Docket Item # 21
BAR CASE # 2015-0268

BAR Meeting
September 16, 2015

ISSUE: New Construction: Townhouses

LOCATION: 2 Duke Street

BUILDING 07 OVERALL ELEVATIONS

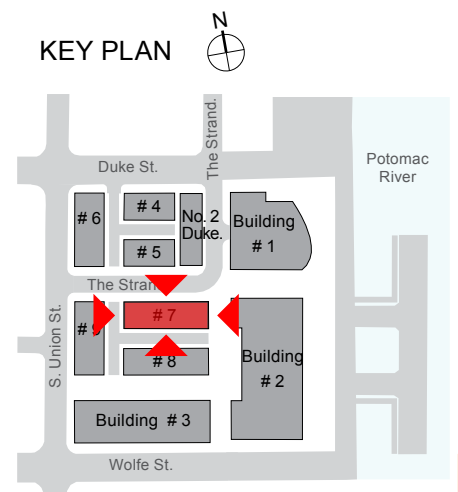
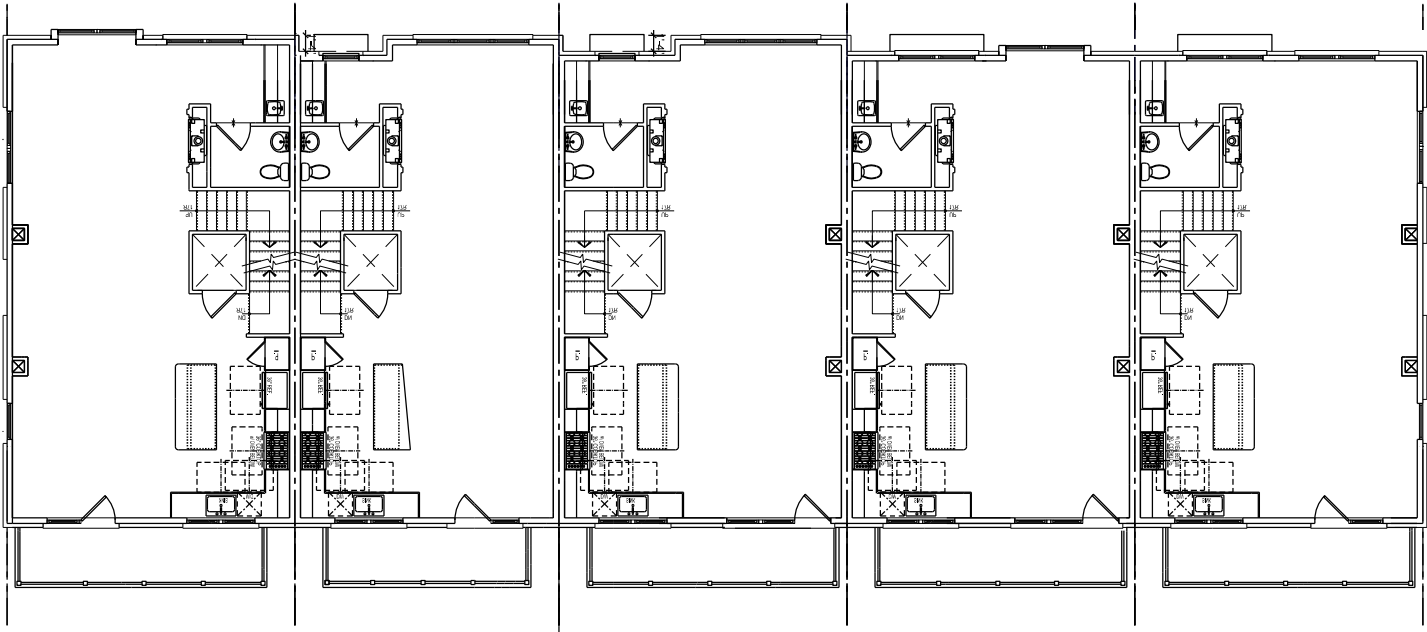
In the current scheme, staff suggests that the two-story applied metal bays such as seen on the Duke Street townhouses be eliminated or reduced in number. This will also simplify this elevation which is adjacent to the historic warehouse, near the future park and across from the future hotel. Such bays could possibly become a feature at the second story to provide architectural interest and showcase fine detailing. Additionally, removing the bays on Building 4 but retaining them on Building 5 would also contribute to a sense of variety within the block, as advised in the paragraph above. The more substantial brick bays as shown on the two interior units such as at Building 7 should be retained and enhanced. Reconsidering how the projecting

DETAIL PLANS AND ELEVATIONS

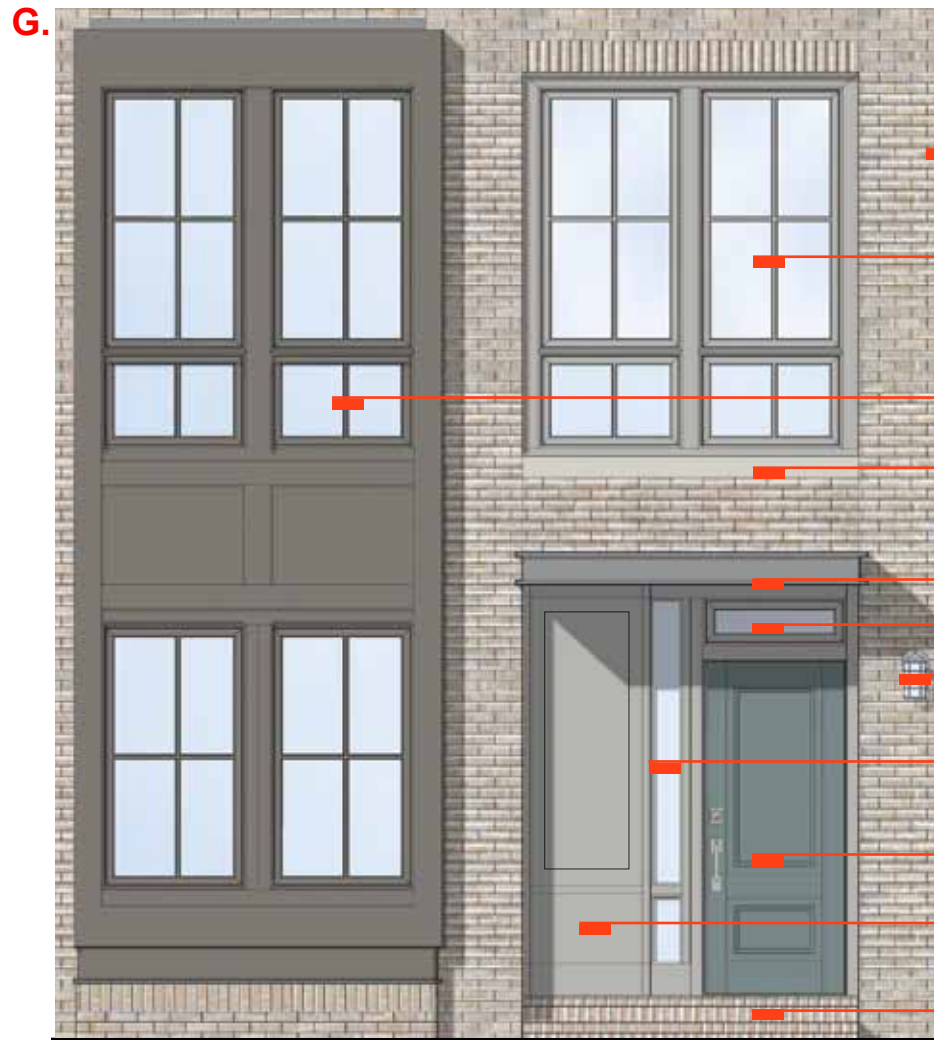
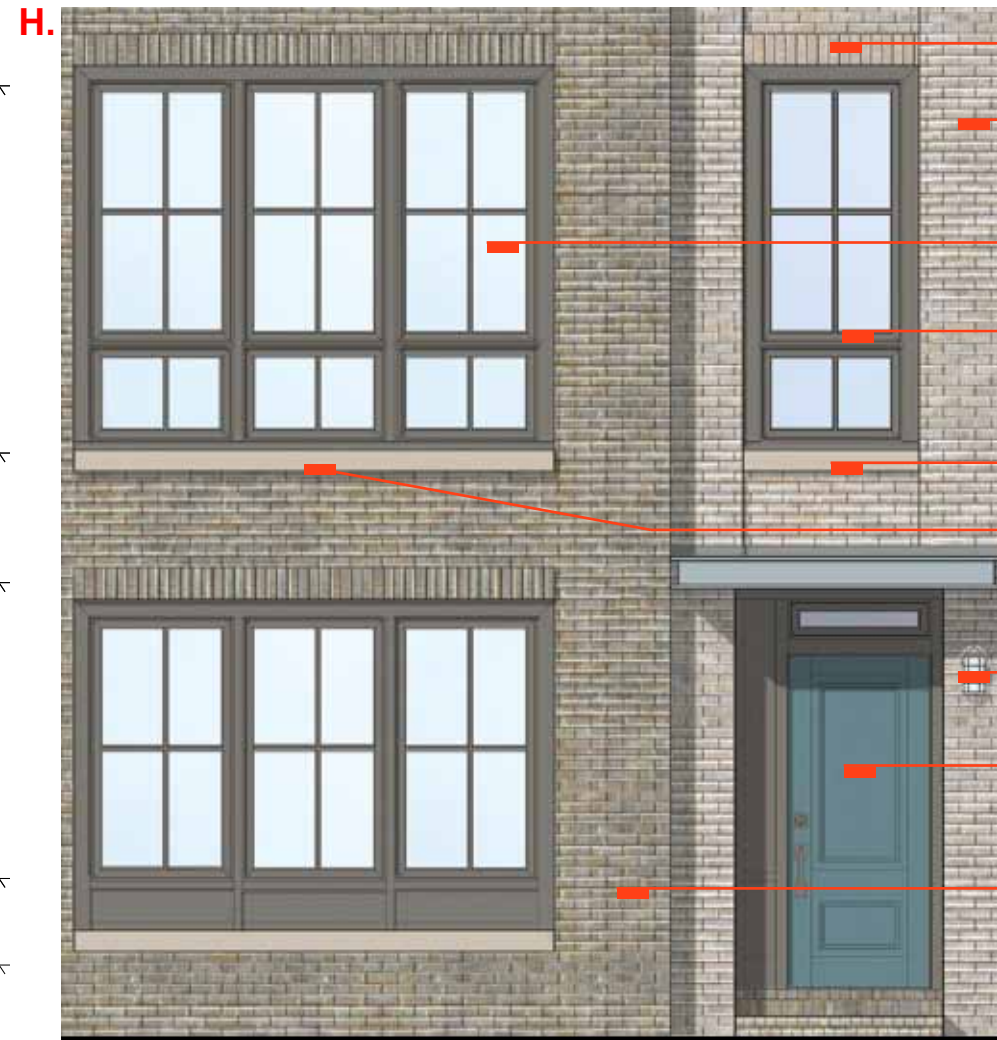
There are a number of locations where a metal panel is proposed beneath windows, such as shown in the detail on Sheet 28. Staff recommends either raising the sill or enlarging the window to eliminate the panel. There may be some places where the metal panel at the windows or a metal spandrel is appropriate, but those should be intentional and used to enhance variety between buildings. Some of the window drawings show slightly off balanced muntin placement which suggests that the window light configuration will not be balanced, such as in the details on

Sheet 28. Staff assumes that this is a drafting error and not an intentional design condition and recommends that future submissions correct this. The metal railings and balconies provide opportunities to showcase a richness of material and craftsmanship as well as convey the residential character of these buildings. This element should continue to be refined and offers an opportunity to provide variety. The applicant should show the proposed locations and number of vents and utilities on all elevations. These should be limited to the rear elevations and appropriately located.
